STAFF REPORT 06-22-2916 MEETING

APPLICATION NUMBER 16-4674

ADDRESS: 1566 BAGLEY

HISTORIC DISTRICT: CORKTOWN

1 SOUTH
A2.1 1/4" = 1'-0"

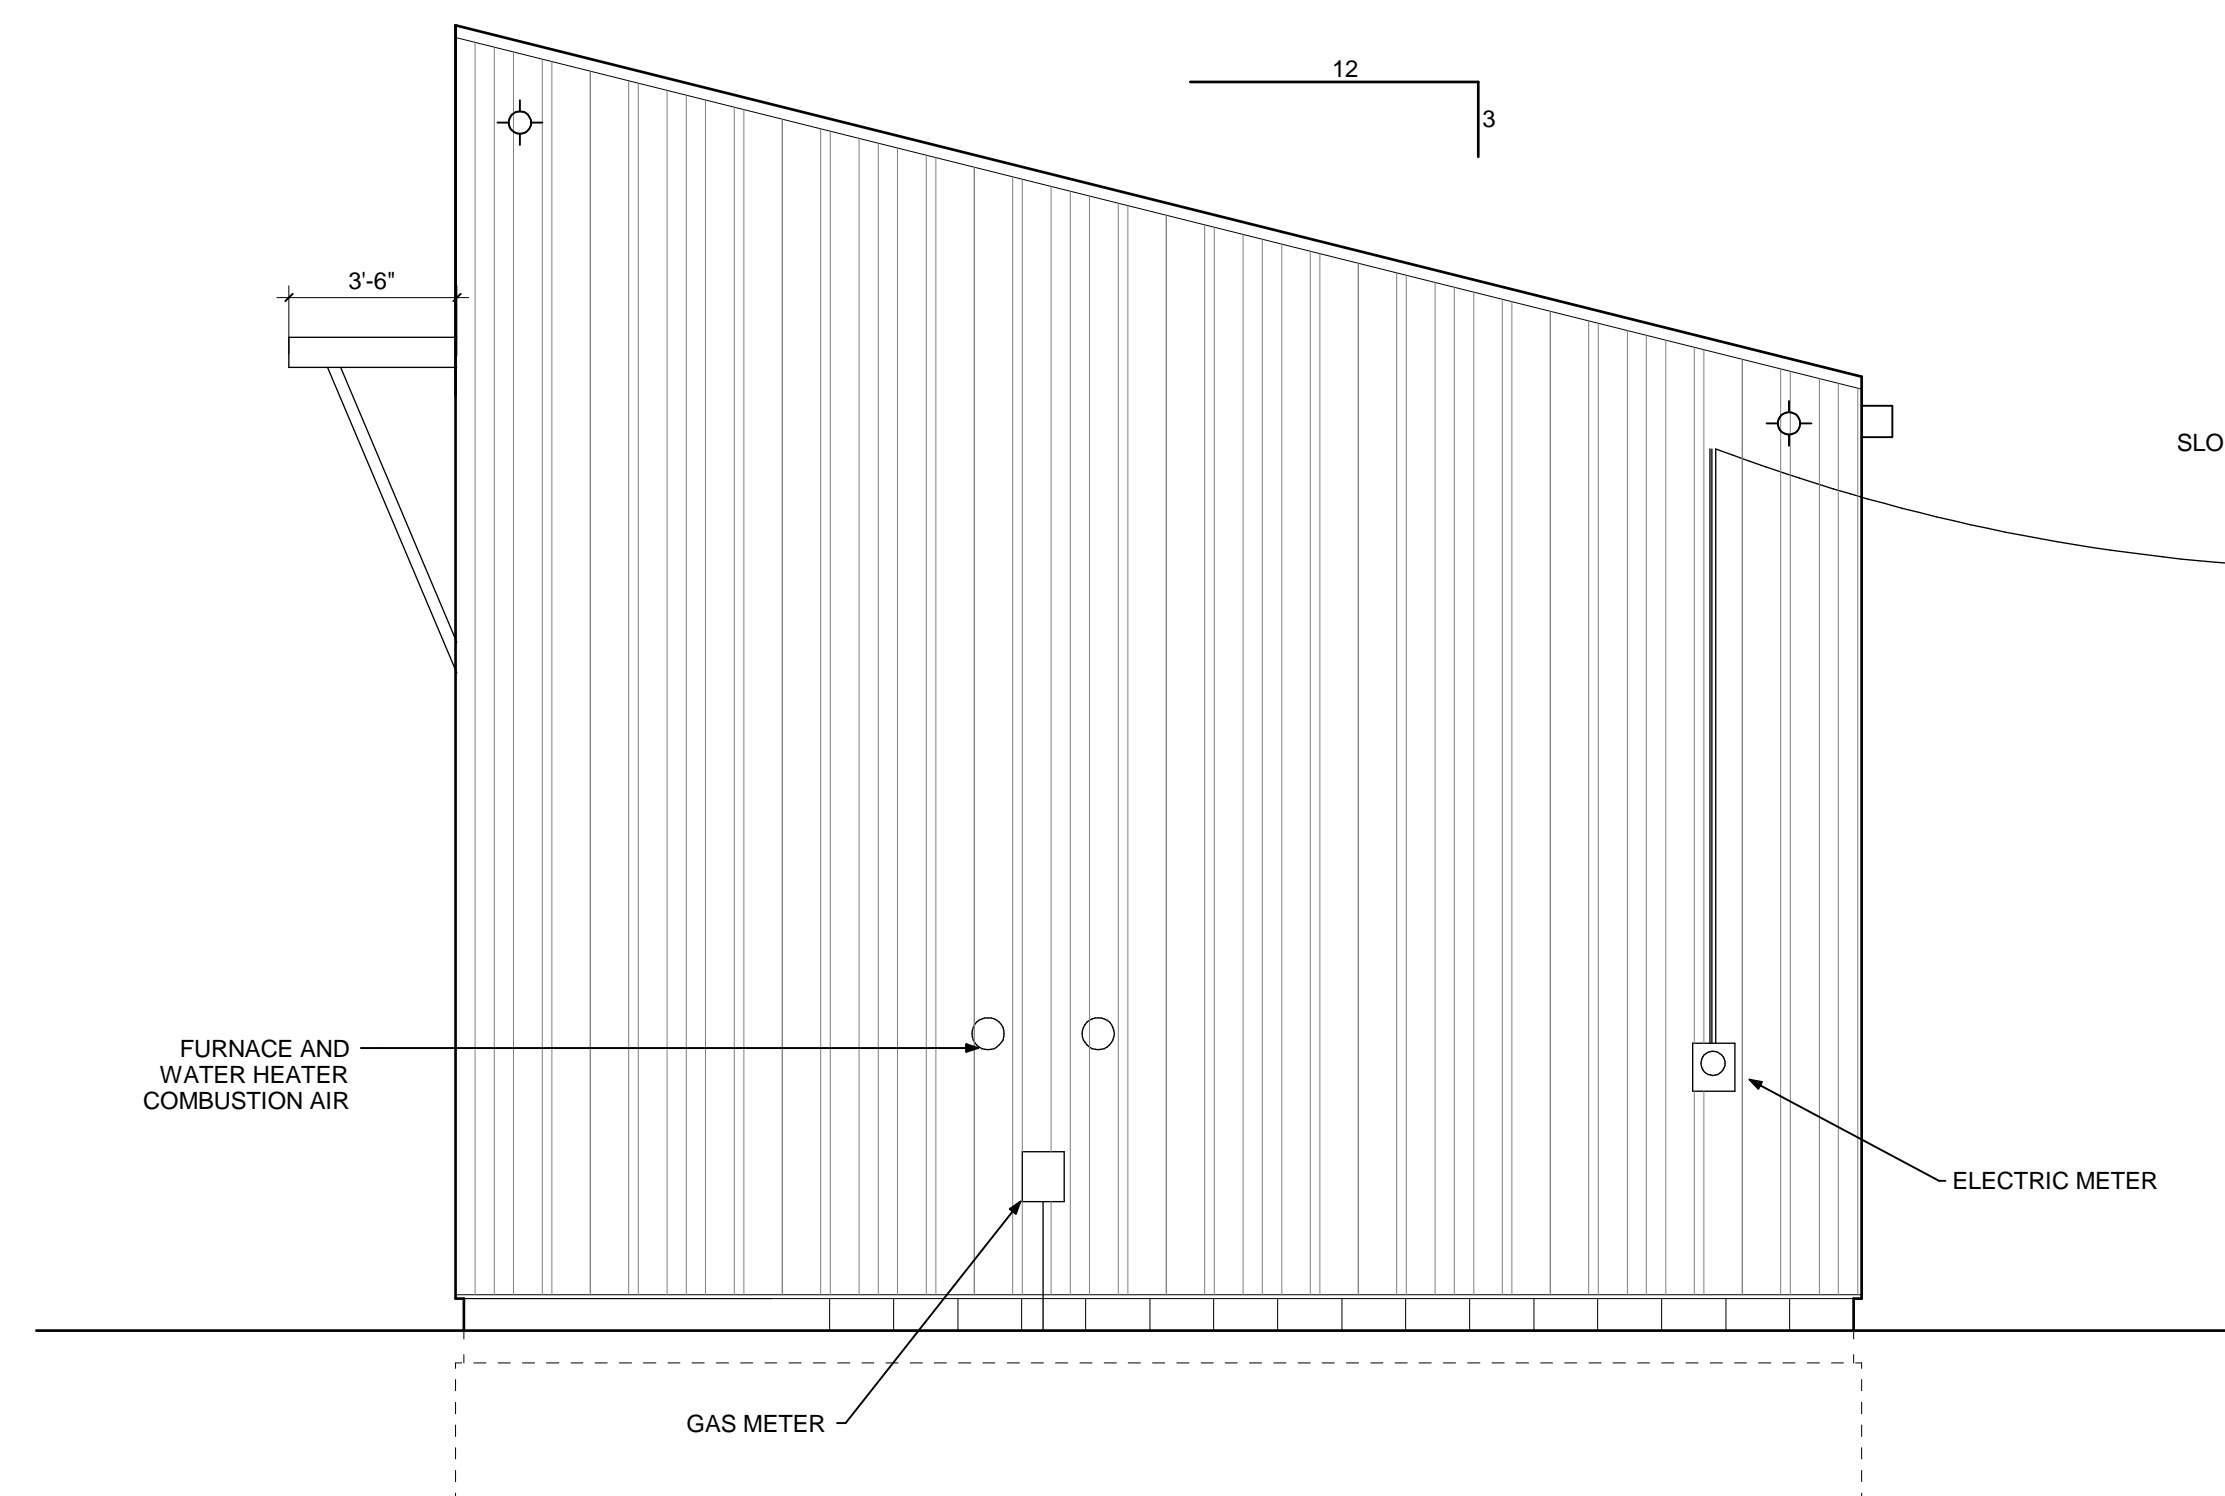
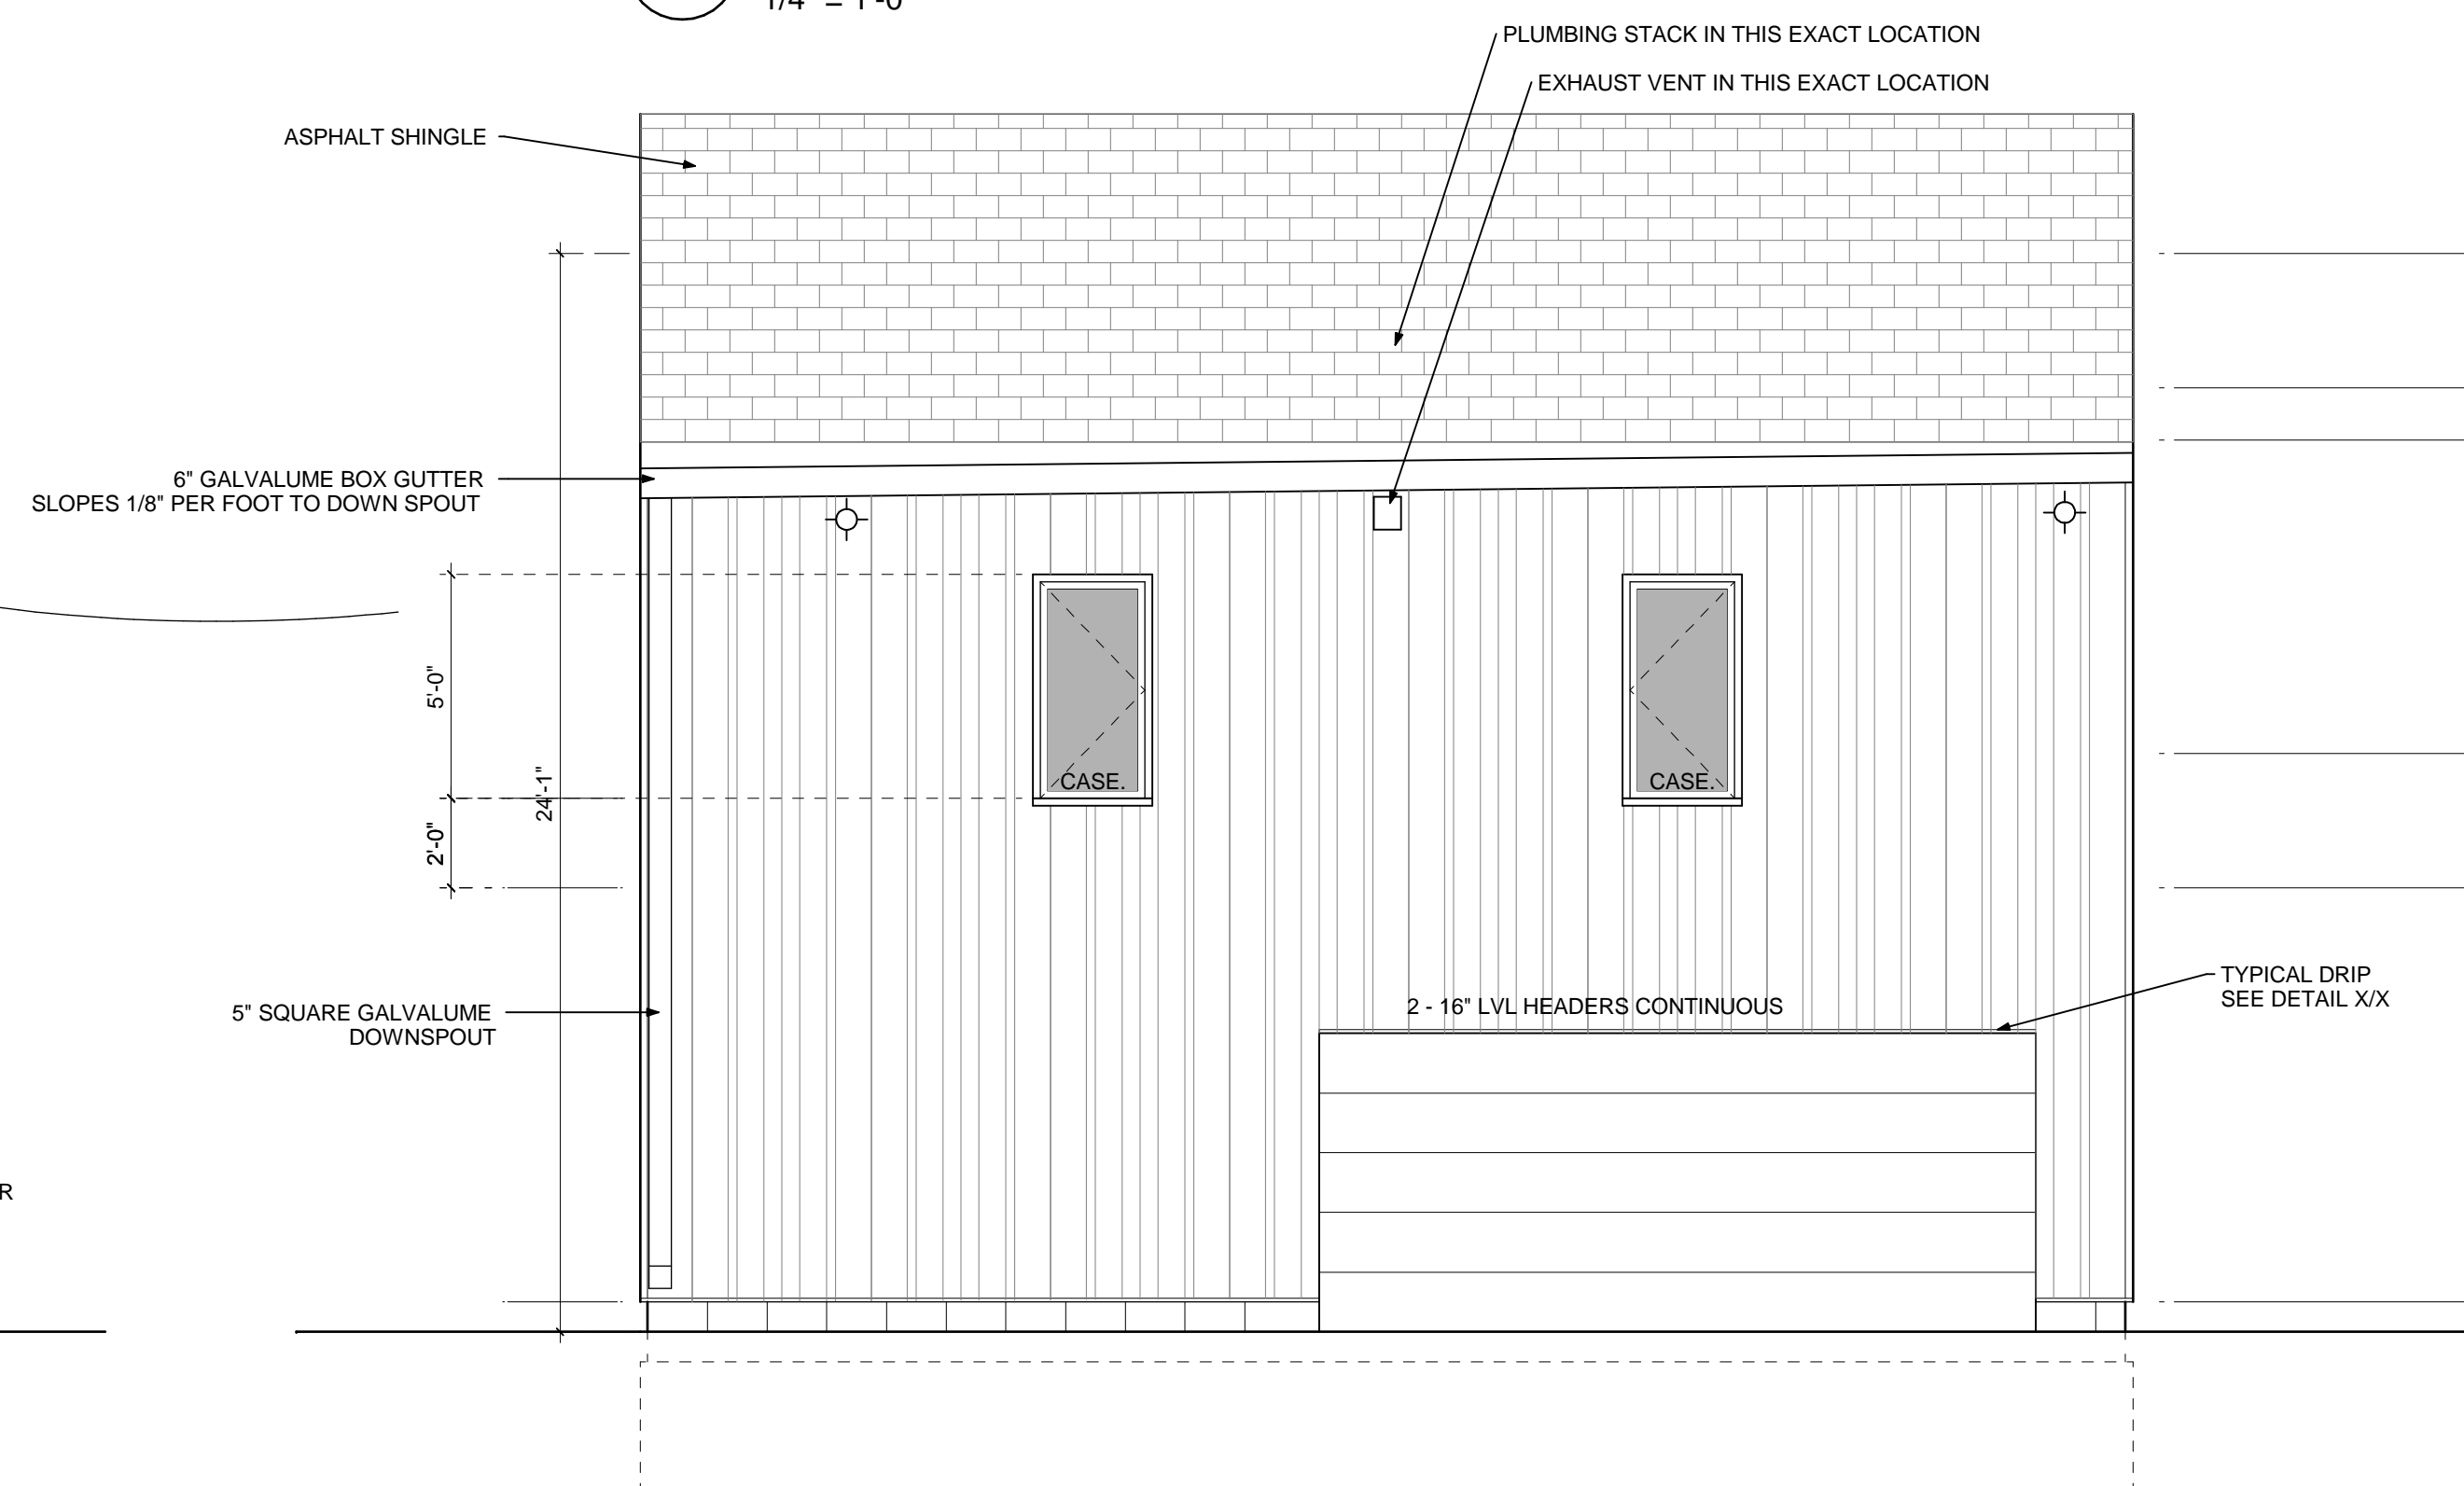
It is noted that the home's setback *is not* consistent with the existing architecture within the 1500 block of Bagley. Also, vertical metal siding is not commonly found at the exterior walls of residential properties within the district. Please see the following *Elements of Design* for the district which and note that the proposed design is generally not in keeping with the neighborhood's prevailing architectural character. However, please see the **submitted narrative** which outlines the applicant's purpose for locating the home to the rear of the lot and discusses their choice of material and the building design. Also, please see the **attached email** from the

- The house shall be clad with a wood siding or masonry so that the building’s appearance is more compatible to the existing historic architecture within the neighborhood. Staff shall be afforded the opportunity to review and approve the siding material and finish color before the COA is issued and the permit is pulled for the work. If staff feels that the selected material does not conform to the district’s Elements of Design, staff shall forward the work item to the Commission for a review at a meeting.

The metal siding was chosen for its durability, modern character but also it's abstract connection to historical board and batten siding. Admittedly there are few examples of vertical board and batten in Corktown and so there is not a direct connection to the context. There is a textural connection that is it is a linear siding that has a board like quality. The Architect and Owner believe this allows the house to relate to but not copy the siding of the older homes. But would to switch to a horizontal metal siding closer to clapboard if the committee so desires.
